STATE OF WASHINGTON
DEPARTMENT OF ECOLOGY

October 27, 2014

Re: Opinion pursuant to WAC 173-340-515(5) on Proposed Remedial Action for the following Hazardous Waste Site:

- **Name:** Penthouse Drapery Cleaners
- **Address:** 1752 Rainier Avenue South
- **Facility/Site No.:** 23408
- **VCP No.:** NW2278
- **Cleanup Site ID No.:** 3184

Figure 2

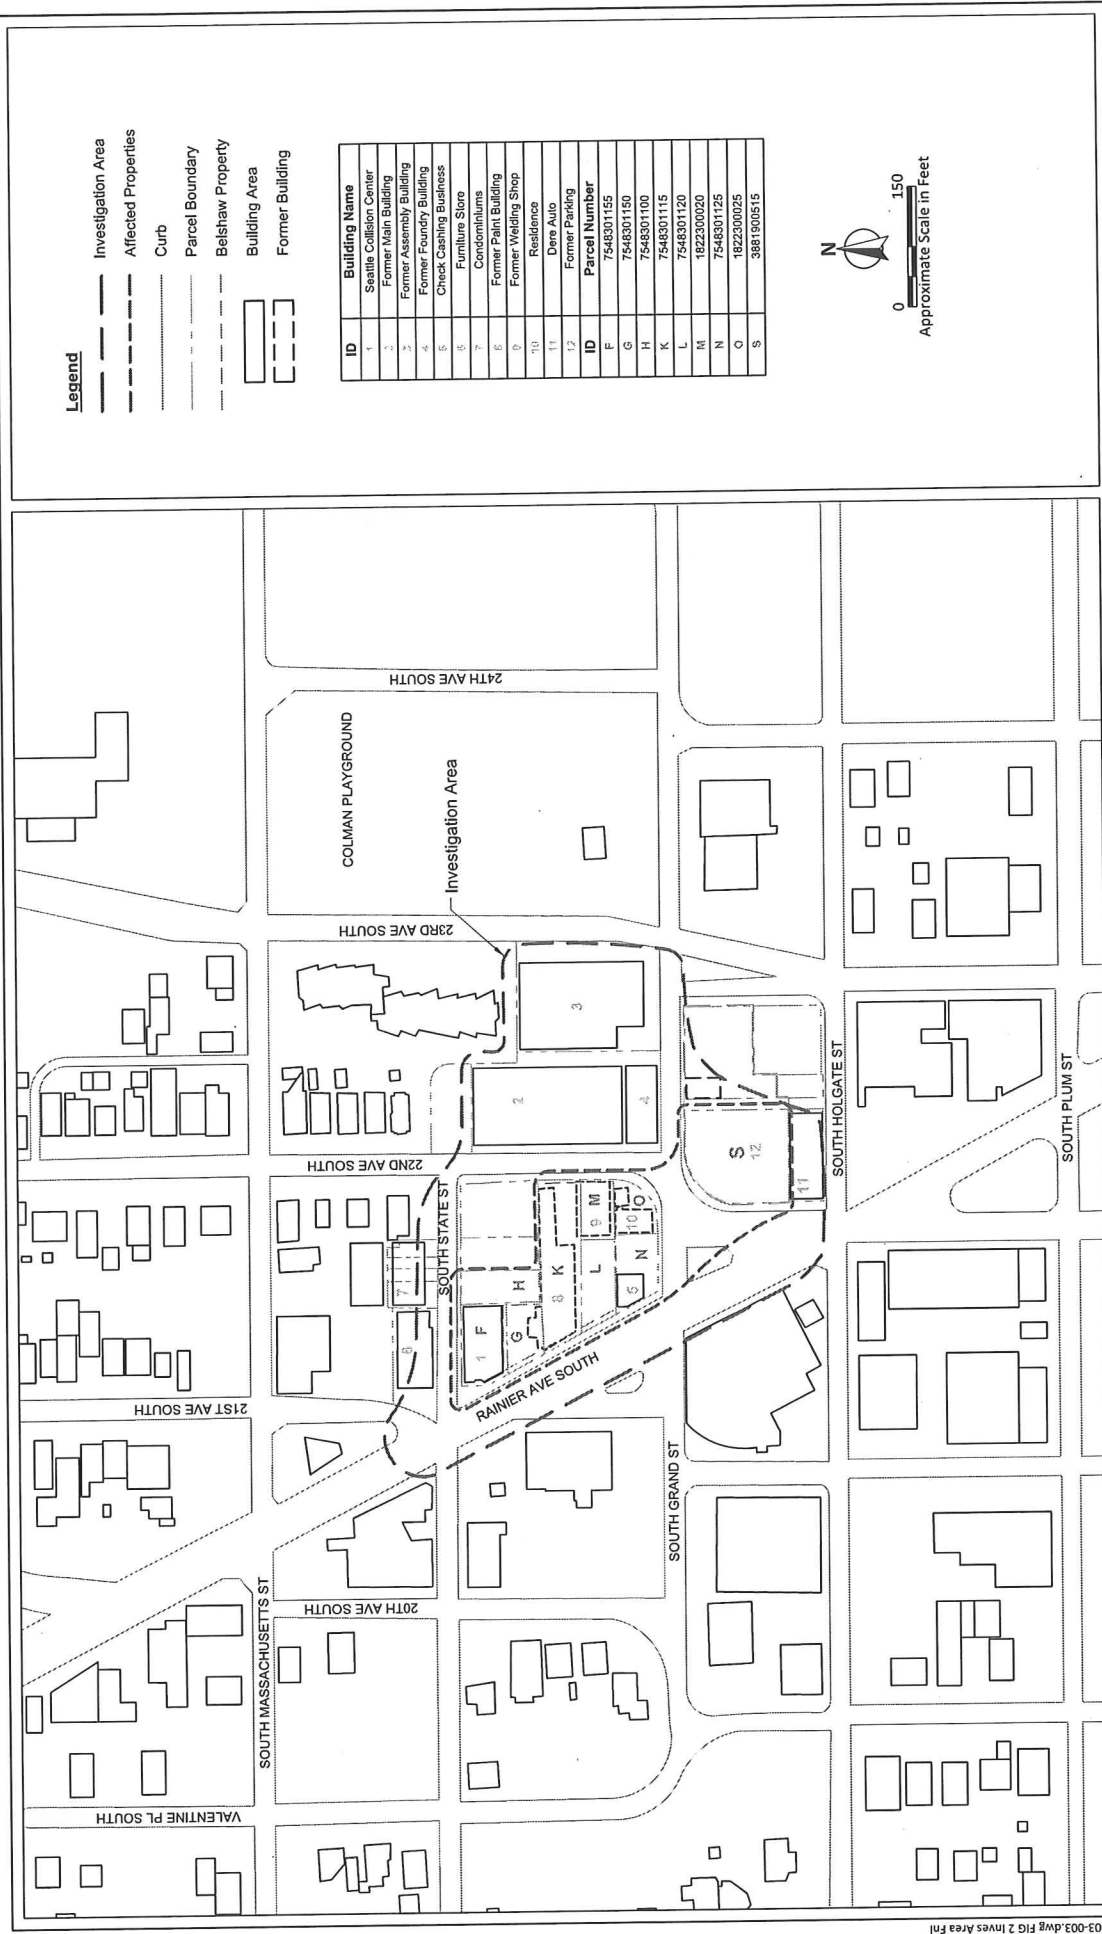
- On Figure 2, the "Investigation Area" boundary does not include the area including the MW-30 monitoring well cluster.
